RE: MEDINA COUNTY
CITY OF BRUNSWICK
CONSTRUCTION STORM WATER
PERMIT NO: 3GC05353*AG
RESERVE AT AUTUMN CREEK
SUBDIVISION, PHASE 1

NOTICE OF VIOLATION

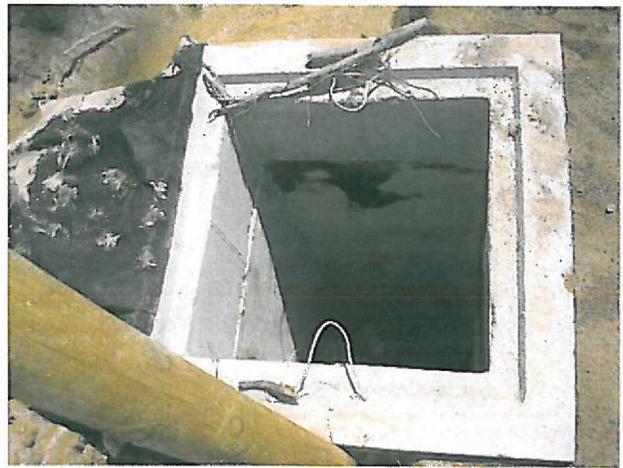
No stabilization present on soil stockpile.

No orrifice was present on this pond's outlet structure.

Missing/removed inlet protection fails to trap sediment.

No rock construction entrance allows for sediment to easily track off site.

Dumpster does not have a tarp or a lid.
